## POOL IMPROVEMENTS

**BALLANTINE PARK  
611 OLD FIELD ROAD  
SOUTHBURY, CT 06488**

S/P+A PROJECT #21.360

**DATE: April 12, 2024**

Drawing Title:  
**POOL PLAN - BID ALTERNATE**

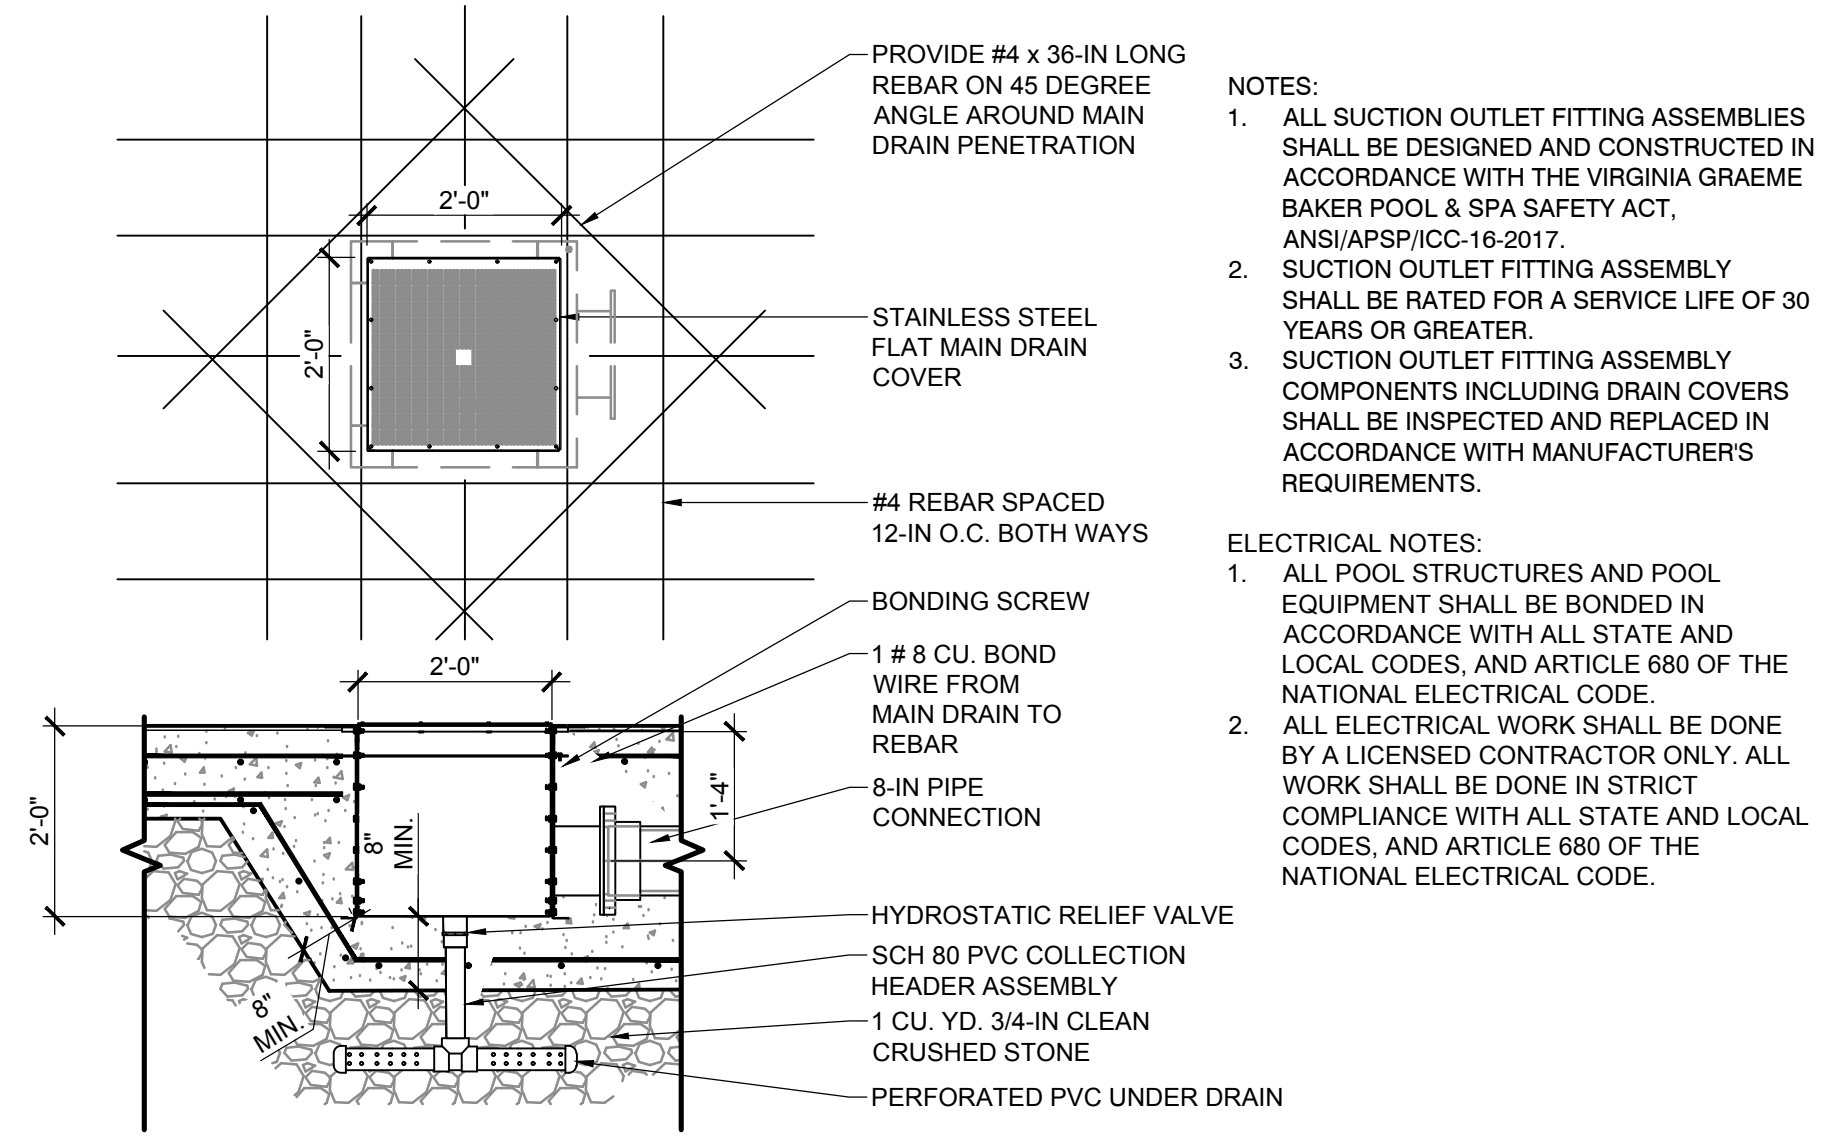
- SECTION 012300, ALTERNATES, Page 2, Article 3.1, add the following:
  - “C. **ALTERNATE #3: Myrtha Pool Wall System:** Include the provision and installation of the stainless-steel modular pool wall system manufactured by Myrtha Pools as indicated on Drawings AQ101 and AQ122 instead of the concrete/shotcrete system that is the Base Bid.

- The following AQUATIC drawings have been added and are attached as part of this addendum\*:
  - AQ101 POOL PLAN – BID ALTERNATE
